Address: 16965 Lindbergh Road, Monument, CO 80132

Use(s):
 Church / religious institution

County File No. PPR2048

DRAWN BY: O.E. WATTS DATE: DWG. NO.: SURVEYED BY: DEV, ESW, 4-29-20	APPROVED BY: PROJ. NO.: DWG. NO.:	REVISIONS	OLIVER E. WATTS CONSULTING ENGINEER COLORADO SPRINGS	PROJECT 16965 LINDBERGH ROAD N1/2, N1/2, NW1/4, SE1/4, SEC. 22, T.11S., R.67W. EL PASO COUNTY	SHIT. NAME SITE DEVELOPMENT PLAN	SHIT. NO. 1 OF
--	---	-----------	--	--	--	----------------------

PARKING DETAIL
 1"=10'

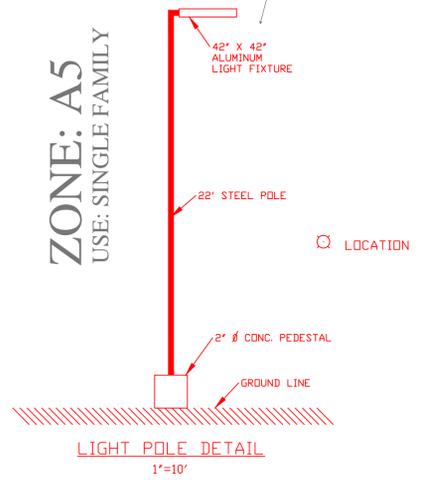
Please add bicycle parking. Per Chapter 6 LDC parking standards: "the minimum number of bicycle parking spaces shall equal 5% of the number of required parking spaces. At least one bicycle parking shall be provided."

Please show and callout an ada route from ada parking spaces to building entrance(s)

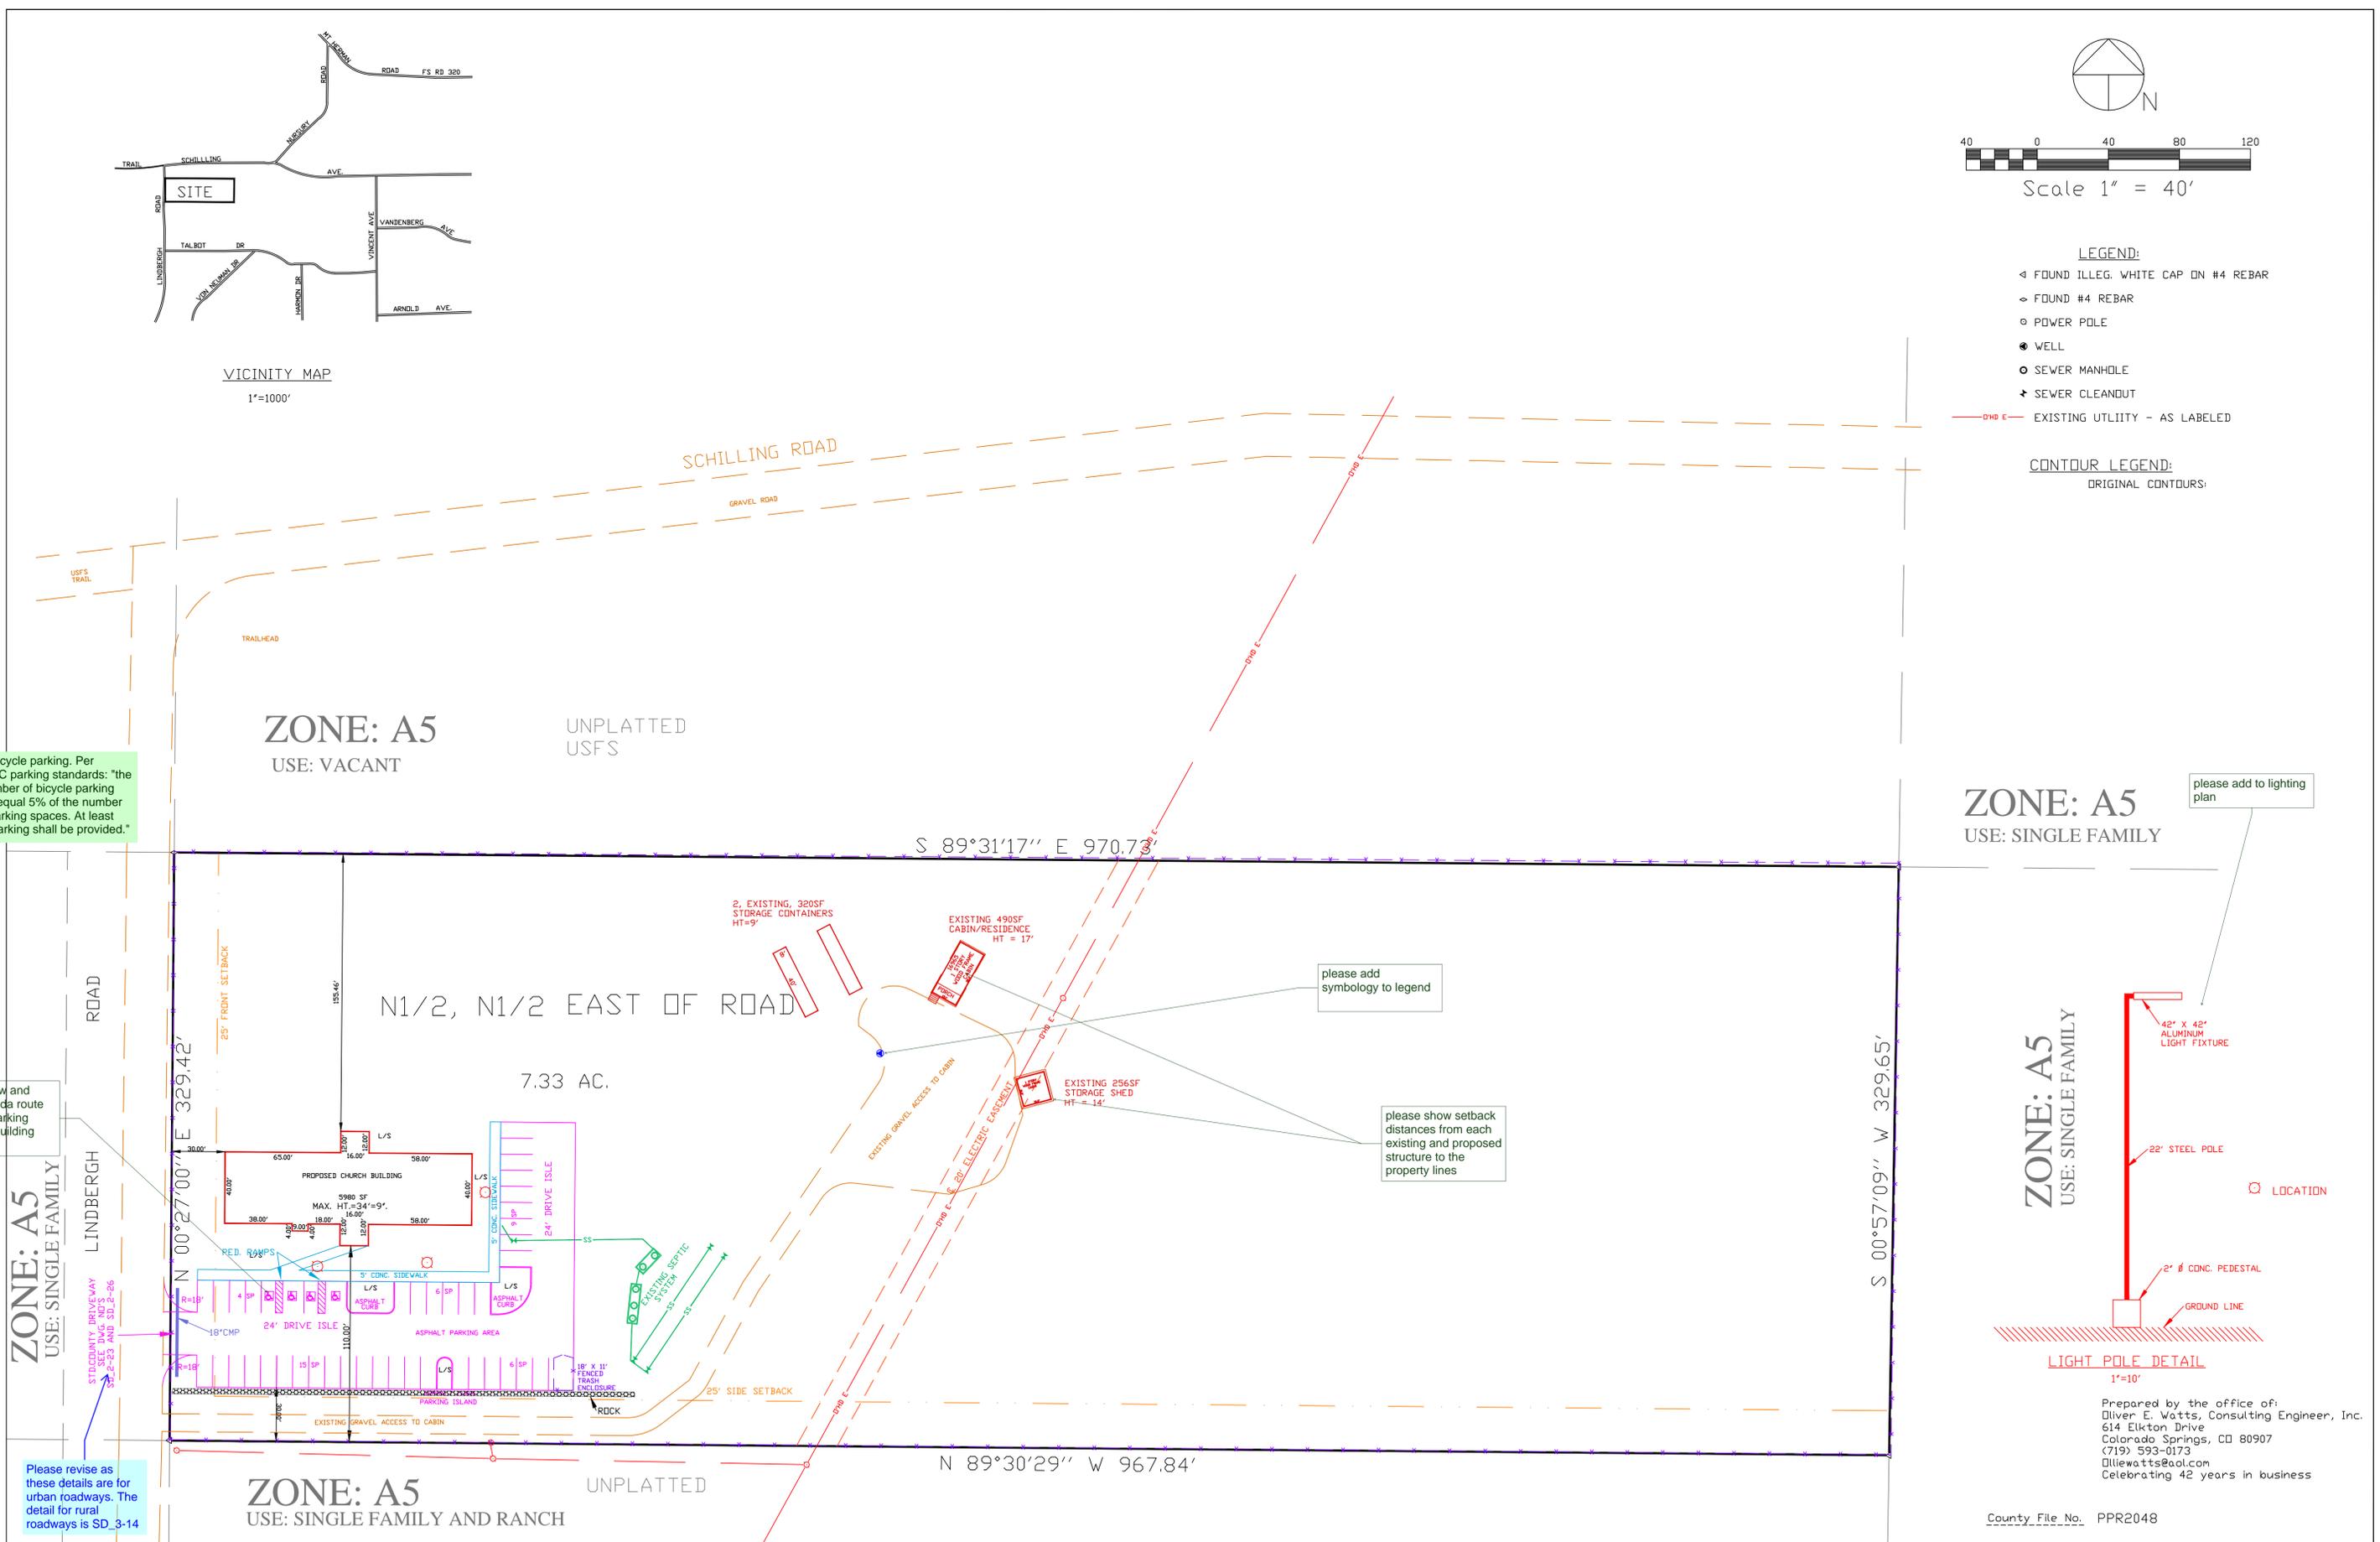
please add to lighting plan

please add symbology to legend

please show setback distances from each existing and proposed structure to the property lines

Please revise as these details are for urban roadways. The detail for rural roadways is SD_3-14
